TVA-SQN-TS-01-09

SEQUOYAH NUCLEAR PLANT (SQN) - UNITS 1 AND 2 - TECHNICAL
SPECIFICATION (TS) CHANGE NO. 01-09, "OPERATIONS INVOLVING
POSITIVE REACTIVITY ADDITIONS" ADDITIONAL CHANGES

PROPOSED TECHNICAL SPECIFICATION (TS) CHANGE NO. 01-09
REVISED MARKED-UP TS CHANGES

3/4.4.2 SAFETY VALVES - SHUTDOWN

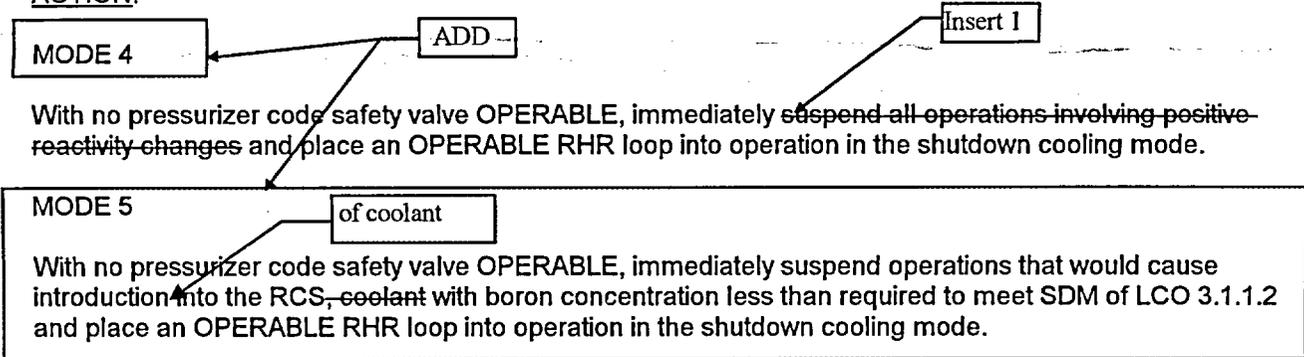
ADD

Insert 1

With no pressurizer code safety valve OPERABLE, immediately suspend all operations involving positive reactivity changes and place an OPERABLE residual heat removal loop into operation in the shutdown cooling mode.

MODE 5

of coolant

With no pressurizer code safety valve OPERABLE, immediately suspend operations that would cause introduction into the RCS, coolant with boron concentration less than required to meet SDM of LCO 3.1.1.2 and place an OPERABLE RHR loop into operation in the shutdown cooling mode.

INSERT 1

suspend operations that would cause introduction into the RCS, ~~coolant~~  of coolant with boron concentration less than required to meet SDM of LCO 3.1.1.1
